## ADDENDUM IDAP REPORT

<b>Property:</b>	33 Hillcrest Avenue STRATHFIELD SOUTH DA2020/223
<b>Proposal:</b>	Demolition of existing structures and construction of a two (2) storey dwelling house with basement level, an in-ground swimming pool and associated external and landscaping works.
<b>Applicant:</b>	Urban Link Pty Ltd
<b>Owner:</b>	A Yassine
<b>Date of lodgement:</b>	3 December 2020
<b>Date of IDAP Meeting:</b>	5 March 2021
<b>Notification period:</b>	17 December 2020 to 25 January 2021
<b>Submissions received:</b>	One (1)
<b>Assessment officer:</b>	D Strbac
<b>Estimated cost of works:</b>	\$1,805,000.00
<b>Zoning:</b>	R2-Low Density Residential - SLEP 2012
<b>Heritage:</b>	No
<b>Flood affected:</b>	No
<b>Is a Clause 4.6 Variation Proposed:</b>	No
<b>RECOMMENDATION OF OFFICER:</b>	<b>APPROVAL</b>

Figure 3: Revised basement design with new designated storage areas.

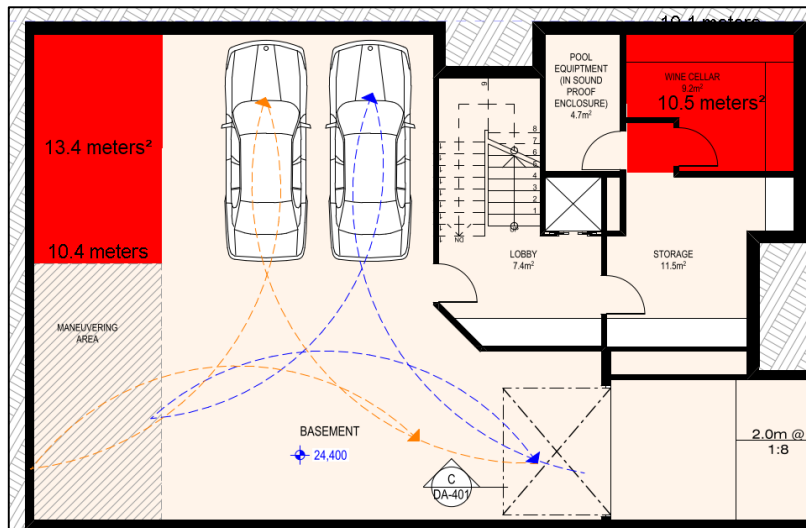
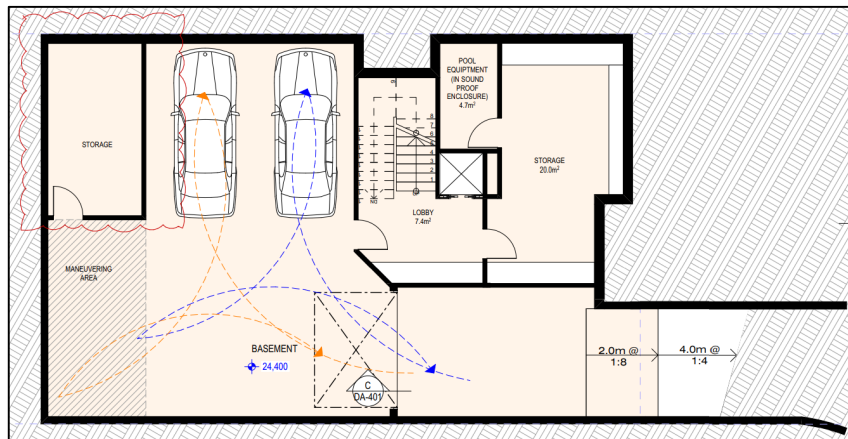
1. *Identify the additional floor area as designated storage areas in the basement level.*

Figure 2: Areas of basement originally included in GFA calculations highlighted in red.

Assessing Officer's comments: The additional floor areas within the basement level have been designated for storage purposes (refer to Figure 2 and 3 below).

Figure 4: Analysis of adjoining development front setbacks prepared by applicant.

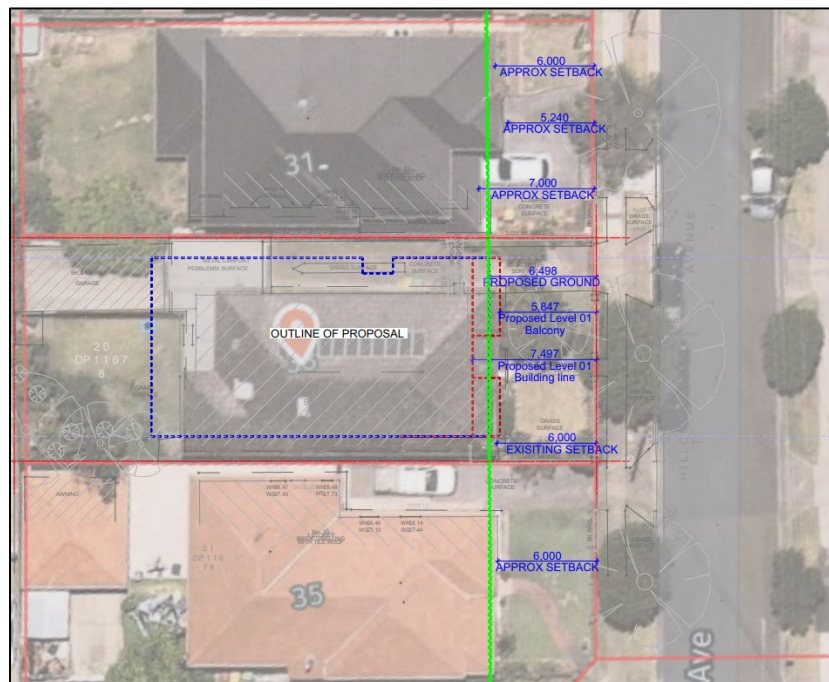
## 2. Increase front setback of the proposed dwelling to 7000mm.

It was confirmed by the applicant that the original set of architectural plans did not accurately display the outline of adjoining dwellings. The correct front setbacks of the adjoining dwellings are 5240mm (31 Hillcrest Avenue) and 6000mm (35 Hillcrest Avenue) (refer to Figure 4). A front setback of 5847mm is therefore considered to be appropriate and demonstrates consistency

with the streetscape. Notwithstanding IDAP's request for a 7000mm front setback, the proposed 5847mm is considered to be supportable and acceptable.
